APPEAL SUMMARY

Appeal ID: 24870	Project Address: 2400 NE Broadway St.
Hearing Date: 5/12/21	Appellant Name: Rebecca Morello
Case No.: B-011	Appellant Phone: 2487612001
Appeal Type: Building	Plans Examiner/Inspector: Chanel Horn
Project Type: commercial	Stories: 1 Occupancy: A-2, F-2, S-2, S-1 Construction Type: V-B
Building/Business Name:	Fire Sprinklers: Yes - Throughout
Appeal Involves: Alteration of an existing structure, Reconsideration of appeal	LUR or Permit Application No.: 20-146115-000-00-CO
Plan Submitted Option: pdf [File 1] [File 2] [File 3] [File 4] [File 5] Proposed use: Brewery

NE BROADWAY BREWERY

CODE PLAN - MAIN LEVEL

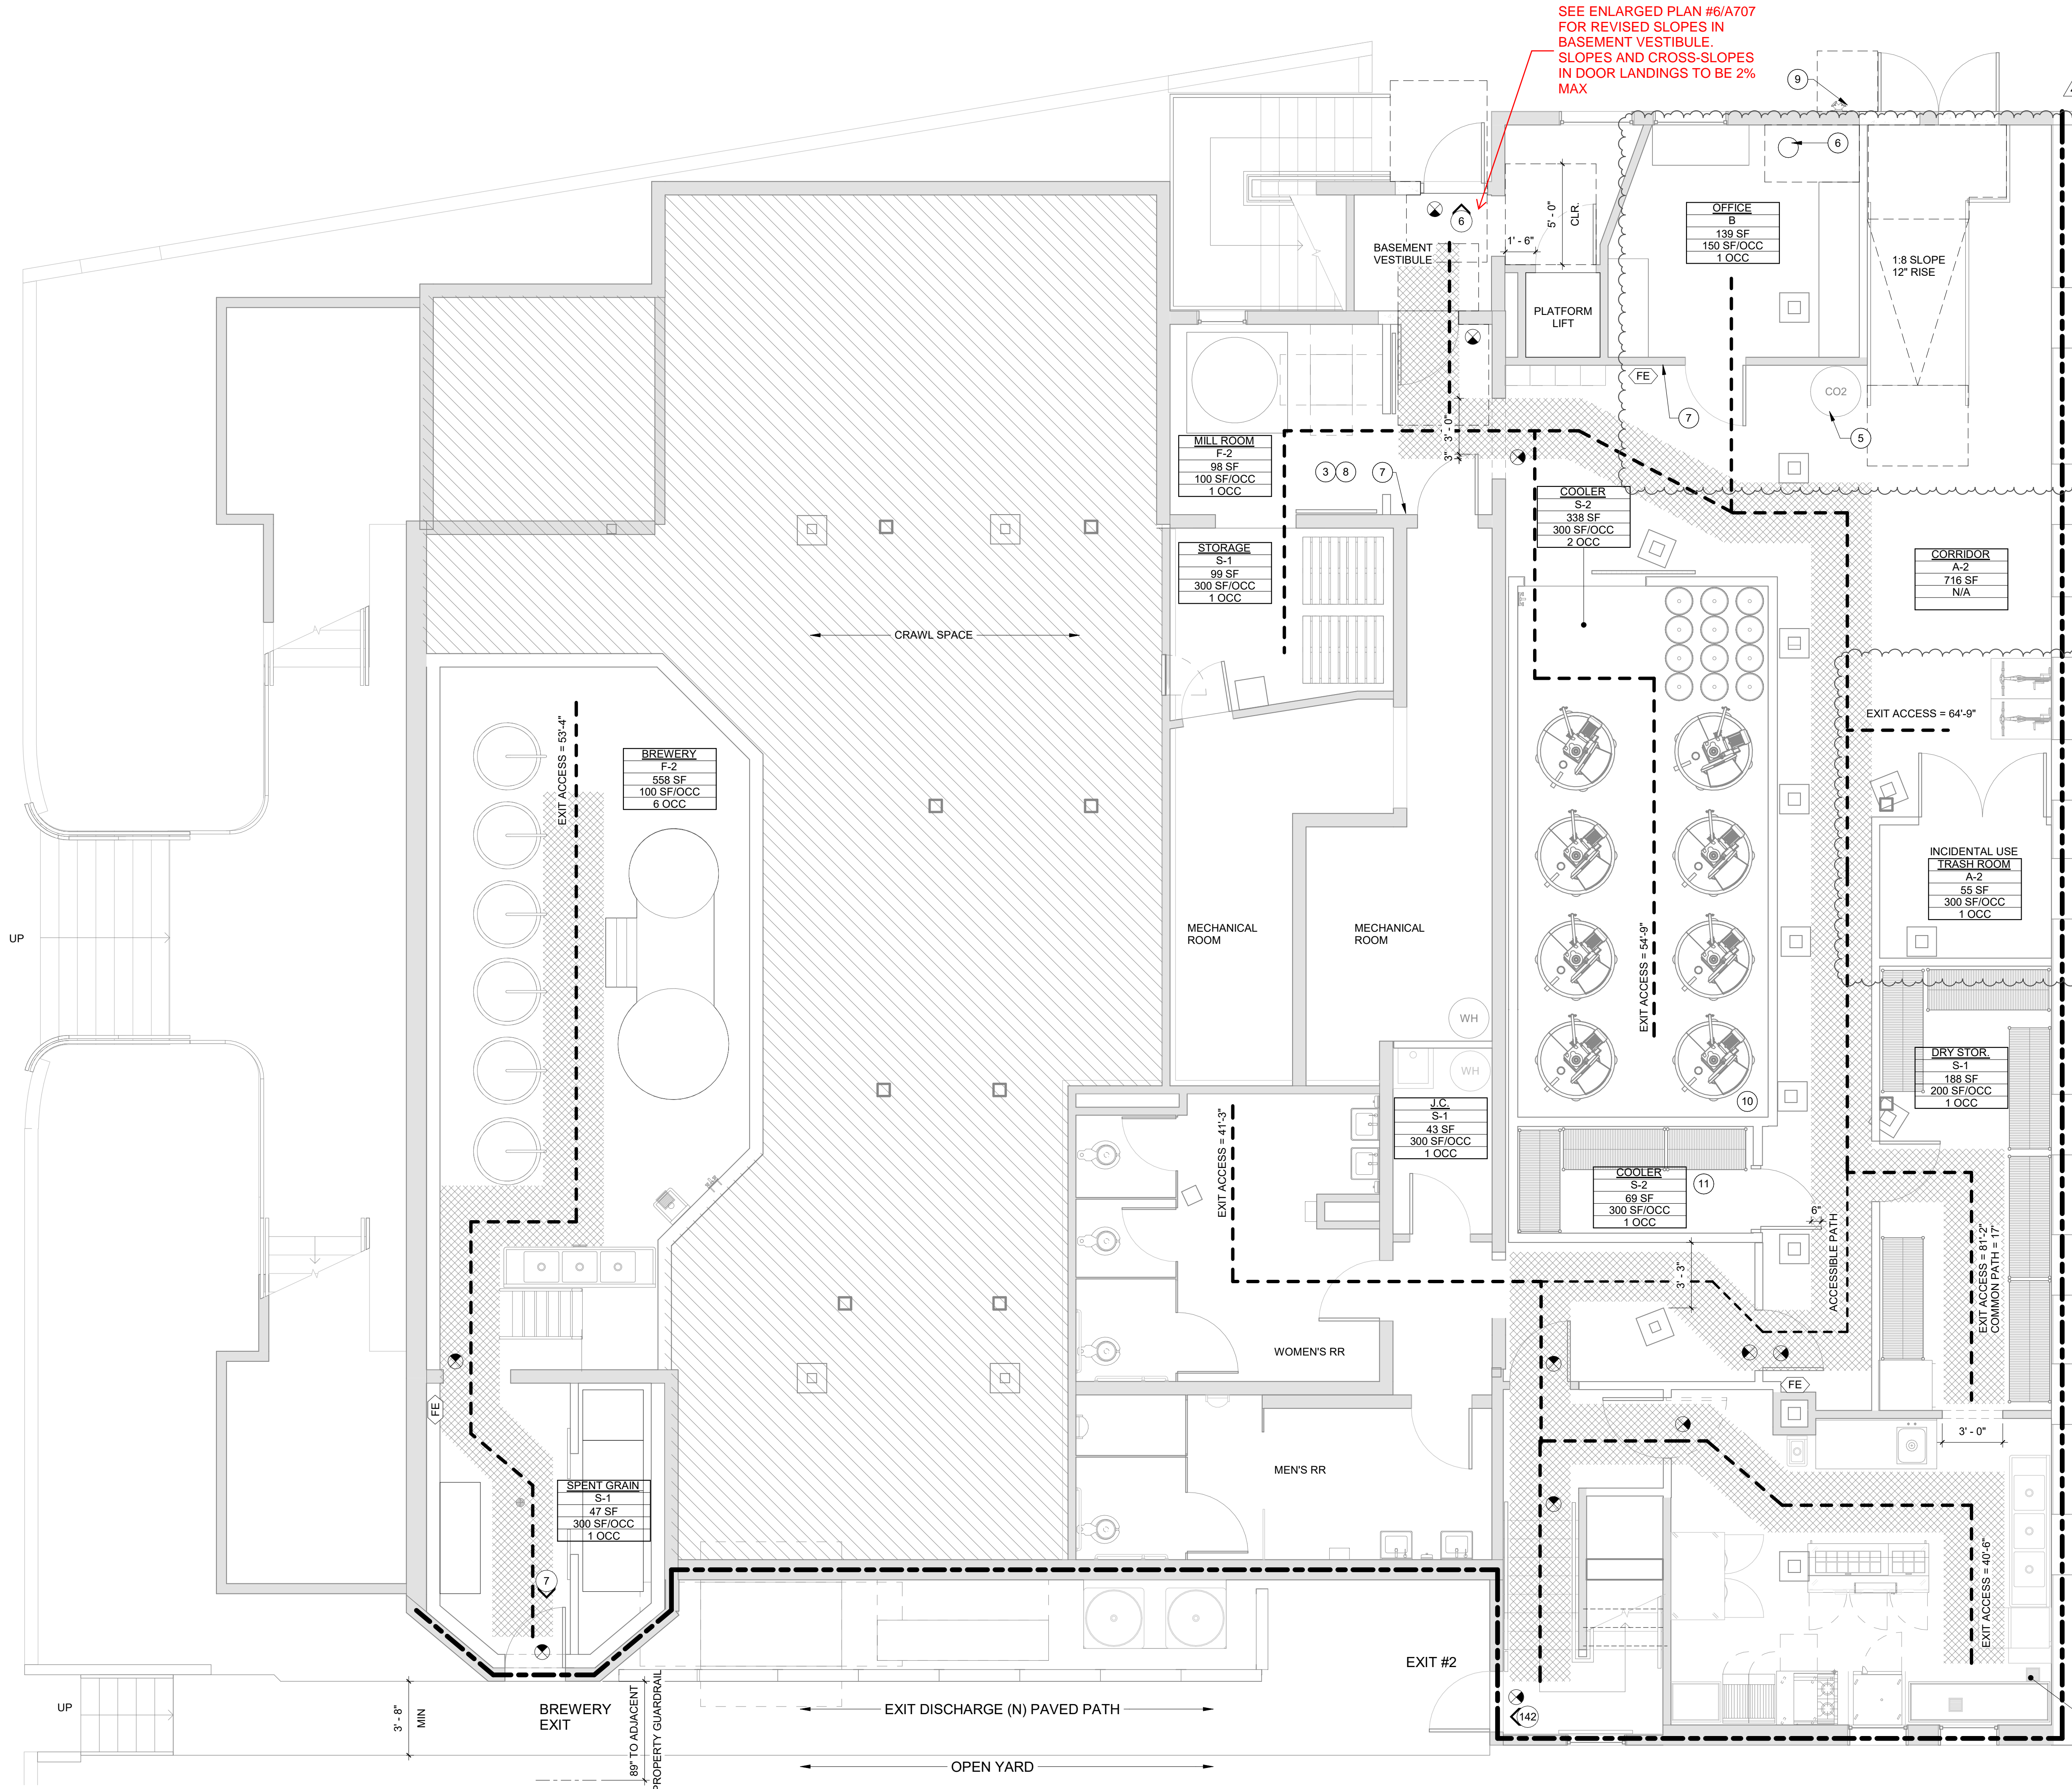
Code Section	1010.1.5 Floor Elevation
Requires	There shall be a floor or landing on each side of a door. Such floor or landing shall be at the same elevation on each side of the door. Landings shall be level except for exterior landings, which are permitted to have a slope not to exceed .25 unit vertical in 12 units horizontal (2-percent slope).
Code Modification or Alternate Requested	<p>Reconsideration Text: The intent of the appeal is to allow 2% maximum slopes and cross-slopes within the interior door landings of the basement vestibule</p> <p>Original Text: The intent of the appeal is to allow the existing interior non-level landings at the doorways in the basement entry vestibule to remain, in order to maintain access to the existing platform lift.</p>
Proposed Design	<p>Reconsideration Text: The existing door landings at the northern entry to the basement are non-level. The exterior entry has an existing slope of 17% and the interior door landing is sloped at 4%. The existing exterior door landing will be re-graded and paved to a 2% maximum slope, meeting the code requirements of OSSC 1010.1.5. The existing interior slope of 4% within the basement vestibule will be adjusted within the door landings of the basement vestibule to be 2% maximum. See detail #6/A707 of the attached drawings (Reconsideration - Details) for an enlarged plan showing slopes.</p> <p>Original Text: The existing door landings at the northern entry to the basement are non-level. The exterior entry has an existing slope of 17% and the interior door landing is sloped at 4%. The existing exterior door landing will be re-graded and paved to a 2% maximum slope, meeting the</p>

code requirements of OSSC 1010.1.5. The interior slope of 4% within the basement vestibule is proposed to remain to maintain access to the existing platform lift.

Reason for alternative Reconsideration Text: The existing building was constructed in the early 1900s and the existing interior basement floor slab is not level within the basement vestibule. The slopes will be leveled out to the maximum extent feasible, but will need to remain sloped at 2% maximum within the door landings due to the existing change in elevations from the public right-of-way to the existing platform lift. A 2% slope meets door maneuvering clearance requirements as defined in 2010 ADA 404.2.4.4 exception 1 and ANSI A117.1 404.2.3.1. The basement consists primarily of employee work areas with low occupant loads totaling 18 occupants. A fully code compliant exit is provided at the southern end of the building for basement occupants providing additional safe means of egress from the basement.

Original Text: The existing building was constructed in the early 1900s and the existing interior basement floor slab is not level within the basement vestibule. Leveling the door landings in the vestibule would create a step of approximately 3" leading to the existing platform lift, which would inhibit occupants in wheelchairs from accessing the lift. It is technically infeasible to alter the pathway to the lift in a code compliant and practical manner due to immediate adjacency of the entry and lift.

The door landings are being brought to compliance to the maximum extent feasible, with the exterior landing being reconstructed to a 2% maximum slope. The interior slope of 4% qualifies as a sloped floor and the basement consists primarily of employee work areas with low occupant loads totaling 18 occupants. A fully code compliant exit is provided at the southern end of the building for basement occupants providing additional safe means of egress from the basement.

1. Interior door landing with 2 percent slopes: Granted as proposed.

SEE ENLARGED PLAN #6/A707
FOR REVISED SLOPES IN
BASEMENT VESTIBULE.
SLOPES AND CROSS-SLOPES
IN DOOR LANDINGS TO BE 2%
MAX

NORTH STAIR LANDING

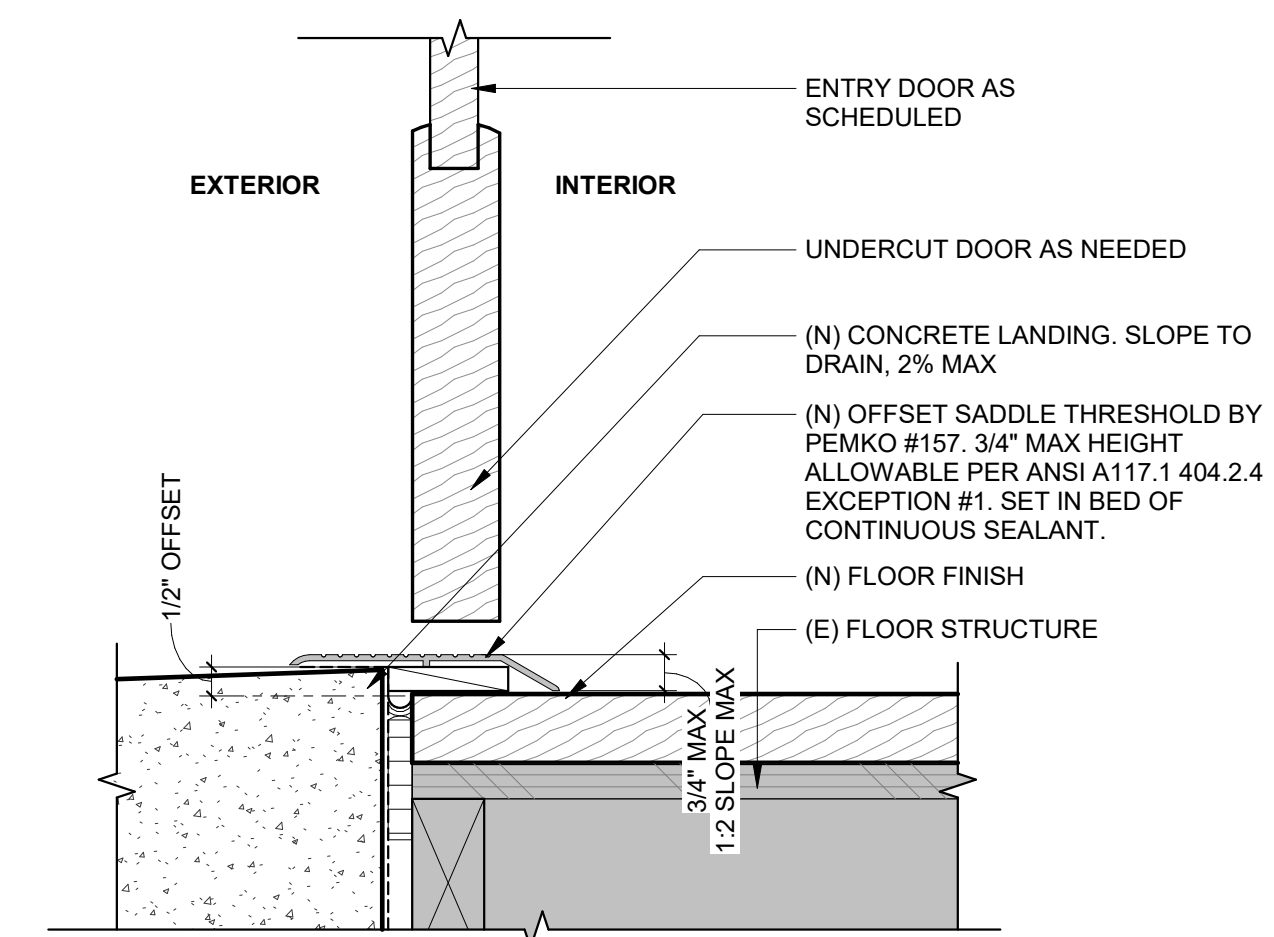
Code Section	1014.6 Handrail Extensions
Requires	Where handrails are not continuous between flights, the handrails shall extend horizontally not less than 12" beyond the top riser
Code Modification or Alternate Requested	The intent of the appeal is to allow the new handrail mounted to the building facade at the northern exterior stairs to be installed without the top handrail extension due to the existing plan configuration.
Proposed Design	The existing handrails and guardrails at the northern exterior stair are not code compliant. These handrails and guardrails are proposed to be replaced with new rails that are compliant to the maximum extent feasible. The floor mounted handrail will have the required extensions at the top and bottom stair landings. The wall mounted handrail will have the bottom extension but is proposed to be installed without the 12" extension beyond the top riser.

Reason for alternative Reconsideration Text: An additional stair riser is required to be added to the top of the existing stair landing in order to create a code compliant door landing at the existing pair of doors. When this new riser is added, the wall mounted handrail will no longer be able to meet extension requirements. Per Per ANSI A117.1 505.10 exception 3 – in alterations, full extensions of handrails shall not be required where such extensions would be hazardous due to plan configuration. Blocking a door leaf would create a hazard and is not avoidable due to the plan configuration of the existing doors. We are improving the safety of the existing stair by creating a compliant door landing, replacing the handrails and guardrails with rails that comply with code to the maximum extent possible, and providing a handrail on the opposite side of the stair that will have a full extension beyond the top riser.

Original Text: The handrail mounted to the building façade cannot extend 12" beyond the top riser due to the plan configuration of the entry doors. The extension would impede the function of one leaf of the pair. We are improving the safety of the stair by replacing the handrails and guardrails with rails that comply with code to the maximum extent possible and the handrail on the opposite side of the stair that will have a full extension beyond the top riser.

2. Omission of handrail extensions: Denied. Proposal does not provide equivalent Life Safety protection. Appellant may contact Josh Weeks (503 823-8834) with questions.
